# HISTORIC AND DESIGN REVIEW COMMISSION

**HDRC CASE NO:** 2024-119  
**ADDRESS:** 600 HEMISFAIR PLAZA WAY  
**LEGAL DESCRIPTION:** NCB 13814 BLK 3 LOT PT OF 12 ARB 12G (GIS AC 3.847 AC)  
**ZONING:** D, RIO-3, H  
**CITY COUNCIL DIST.:** 1  
**DISTRICT:** Hemisfair Historic District  
**APPLICANT:** Andres Andujar/Hemisfair Park Area Redevelopment Corp  
**OWNER:** Hemisfair Park Area Redevelopment Corp  
**TYPE OF WORK:** Construction of a covered sports court  
**APPLICATION RECEIVED:** March 15, 2024  
**60-DAY REVIEW:** May 14, 2024  
**CASE MANAGER:** Edward Hall

**Historic and Design Review Commission**  
***Design Review Committee Report***

## Hemisfair Sports Court Pavilion

REFLECTED CEILING PLAN

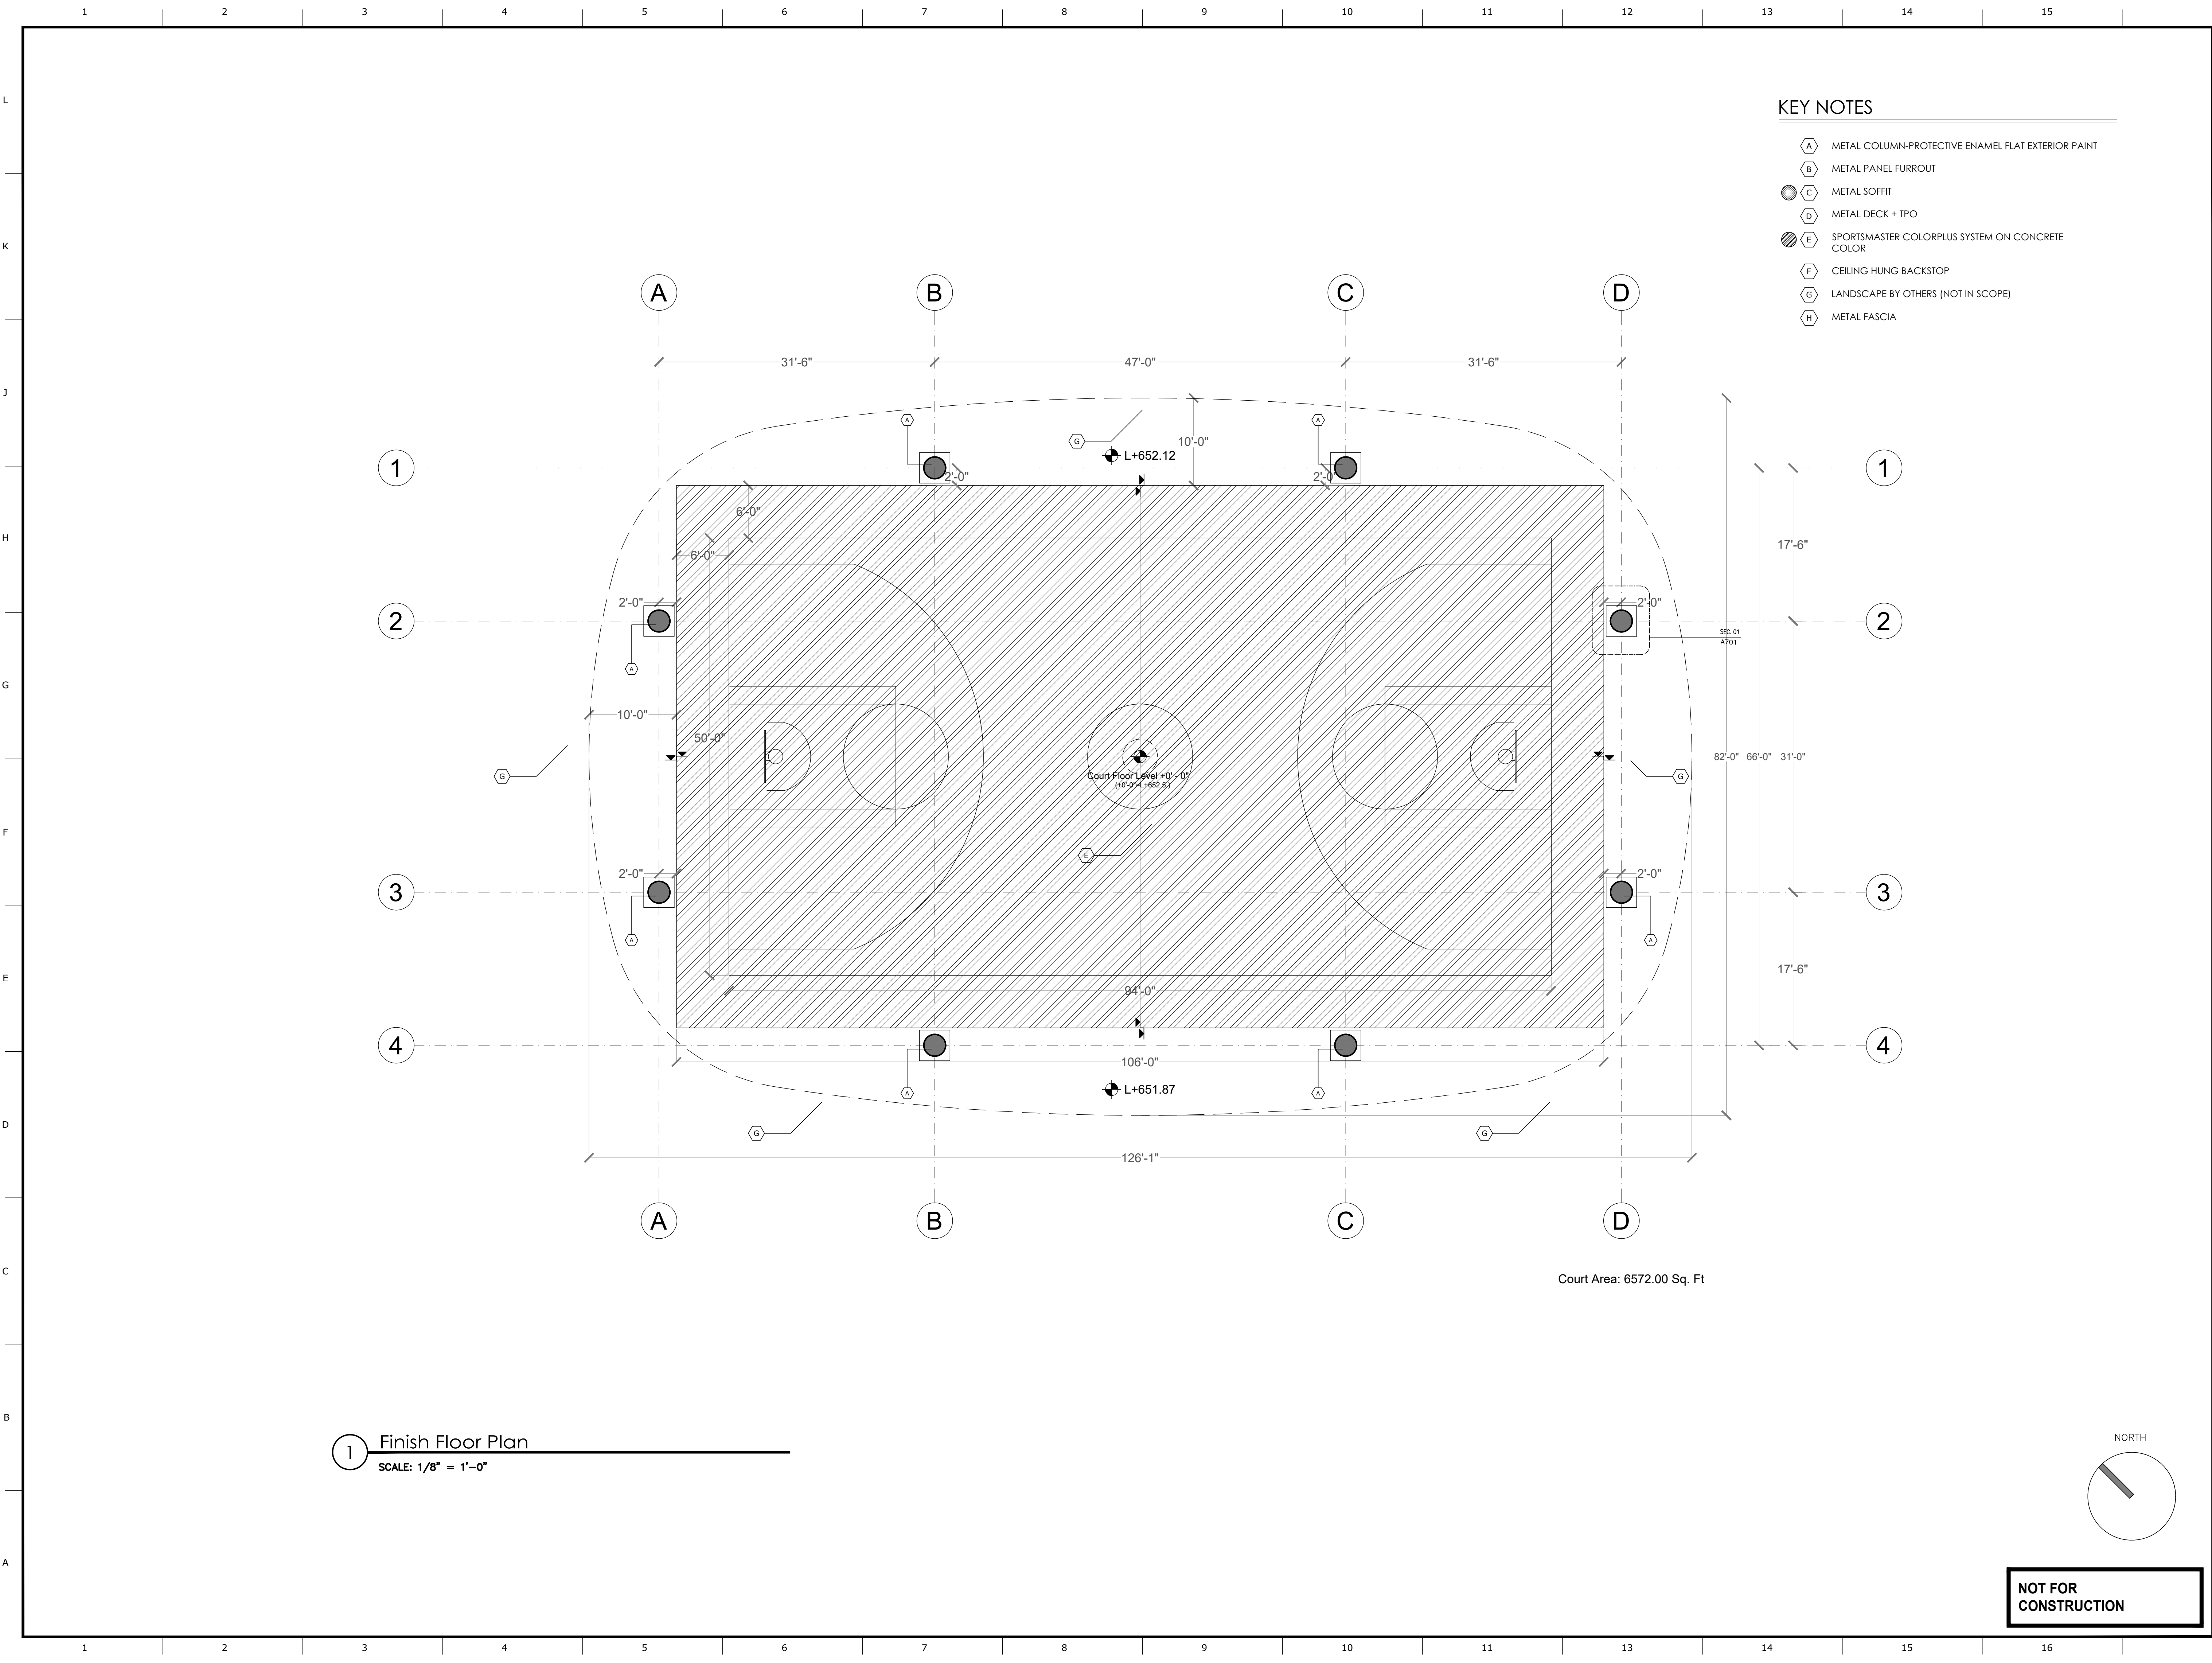
- g. PAVILION (Lighting) – The applicant has submitted a reflected ceiling plan that notes the locations of lighting fixtures. Additionally, the applicant has noted both uplighting and downlighting from the structural columns. Staff finds the proposed lighting to be appropriate and that lighting, as proposed, will not create light pollution throughout Hemisfair.
